**MINUTES  
PUBLIC HEARING ON ENGINEER'S RECOMMENDATION  
ON DRAINAGE DISTRICT 22 TILE REPAIR – 2017**

**WEDNESDAY, AUGUST 2, 2017 AT 11:00 A.M.  
HARDING COUNTY COURTHOUSE**

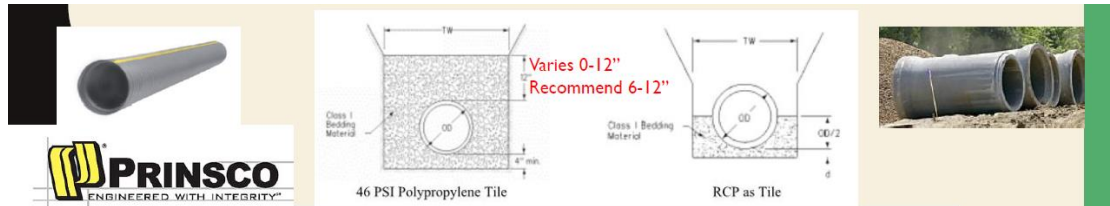
Thomas further explained that they recommend polypropylene pipe for this project but concrete could be bid as an alternative. She described how the tile would be placed in the same trench as the existing tile and that it would be encased in a granular substance with 6-12" above the top of the tile. Landowners voiced concerns with plastic and the depth of the tile. Thomas displayed manufacturer specifications and explained that this thicker product will perform fine for that depth. Madden and Paul Peterson both stated they preferred the concrete method.

1. Replacement of all 30-inch tile outside of the four road crossings. Replacement will be in the same alignment utilizing polypropylene pipe meeting the typical section shown herein with granular Class I material being used for haunch support and backfill to 12-inches above top of pipe. Construction inspection shall include on-site manufacturer’s representative to confirm and field verify installation in accordance with the specified recommendations in addition to internal video investigation approximately 1-month post construction. Any pipe with observable defects shall be immediately replaced.
